Final Report

For:
**Stockport Metropolitan
Borough Council**

COPECAT Audit of A6 to Manchester Airport Relief Road Proposals

September 2013

Diagram 15 A34/A555

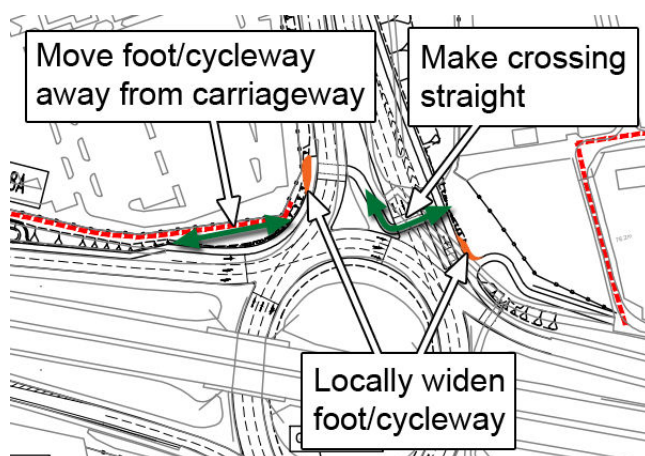
The main concern with this junction is the stagger on the crossing of the southbound A34 approach. The 'sheep pen' on the island separating the left turn and straight ahead flows is long. Its width cannot be measured from the drawing supplied. Making the crossing straight has however, capacity implications.

The foot/cycleway should be locally widened at the ends of the toucan crossings.

The foot/cycleway could be moved away from the carriageway on the north west corner of the junction and combined with footpath 38A.

At the user group meeting held in Fred Perry House on Wednesday 18th September consultees expressed a view that the A34 junction is an appropriate place for a grade separated crossing. A bridge appeared to be the favoured option. However, with both Spath Lane and Earl Road being lower than the A34, a subway is likely to provide a better, more convenient crossing for cyclists and other route users. It would have shorter ramps than a bridge. It is recommended that the Council investigate a subway as well as a bridge at this point.

Diagram 16

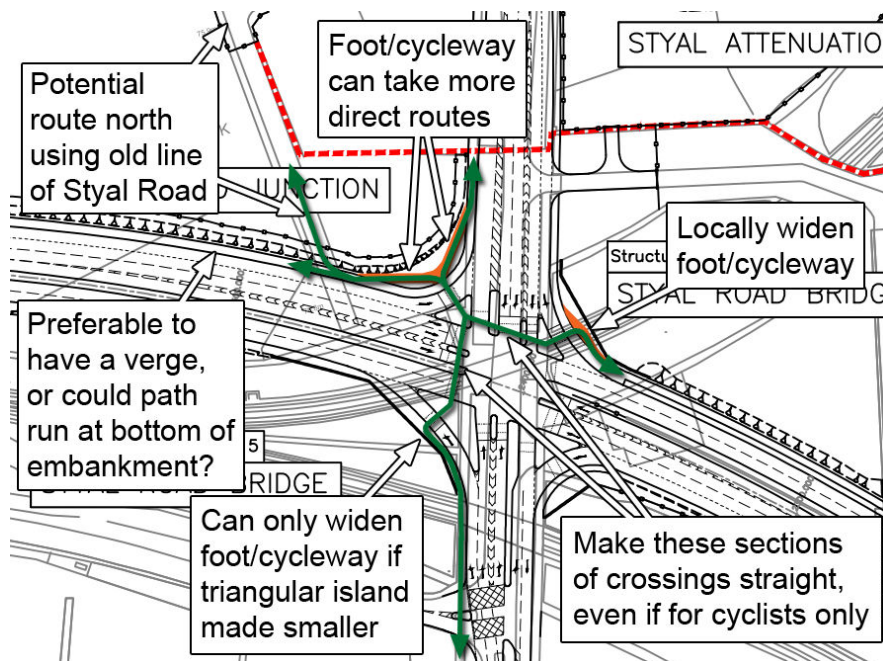
Cycles should be signalled across the junction in fewer stages. Making assumptions about the signal sequencing it should be possible for cyclists to cross the junction in two stages. Cyclists travelling south to east and vice versa will require an additional stage.

The foot/cycleway should be locally widened at the ends of the crossings. On the south west corner of the junction the bridge constrains the available width. The Council should consider whether the triangular island should be made smaller to enable the foot/cycleway to be widened here. On the north west corner of the junction the foot/cycleways could take a more direct route and arrive at the kerb edge in line with the crossing.

It is recommended that the Council considers how to reduce the number of stages involved in the cycle crossings, that the foot/cycleways are locally widened at the ends of crossings and that paths on the north west corner of the junction are straightened and made more direct.

Diagram 17 – issues at the junction of the emergency access and cycle / pedestrian path.

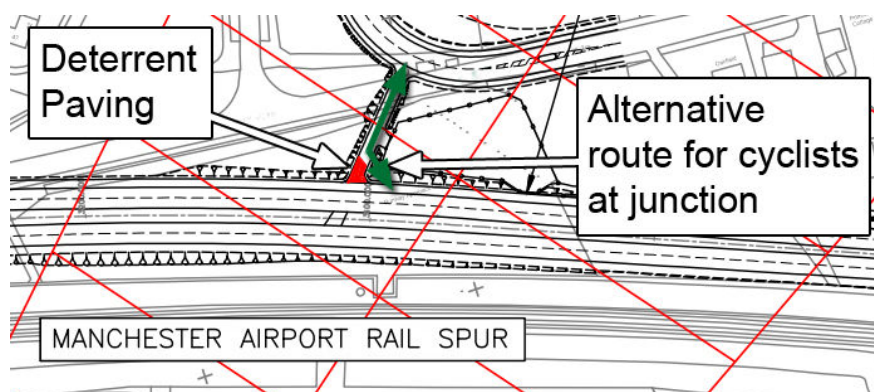
The current design shows the foot/cycleway running alongside the Relief Road. According to the Design Team the path is a 3.0m shared space adjacent to the carriageway. There should be a verge or barrier between a cycle / pedestrian path and the carriageway. As the rest of the path is 2.5m wide it would seem reasonable and consistent that this section of path could be the same width giving space for a 0.5m verge. A verge has a larger maintenance liability than a macadam path. If this additional liability is considered a problem the “verge” could be a 0.5m deterrent strip of different contrasting material. It is therefore recommended that a verge or contrasting strip of at least 0.5m is constructed between the cycle path and the carriageway.

The route would be more useful if it was better integrated with Ringway Road, Shadow Moss Road and the residential areas in south Wythenshawe. Stockport Council has indicated that the emergency access from Ringway Road to the new road could be used by cyclists and pedestrians. If the link was for cyclists and pedestrians only the design would include measures to prevent cyclists failing to make the turn onto the cycle path and entering the carriageway in error. This could be done either by erecting a barrier near the kerb edge or by designing the junction so that cyclists are guided either left or right before joining the path, for instance by designing the junction in the form of a triangle. As the link is to be used by emergency vehicles then a barrier defeats the object of the link. It may be feasible to design the junction with a route for emergency vehicles running over deterrent paving with a smoother route for cyclists and a barrier at the kerb edge. It is recommended that Manchester City Council investigate measures to improve the links between the Relief Road cycle path and south Wythenshawe.
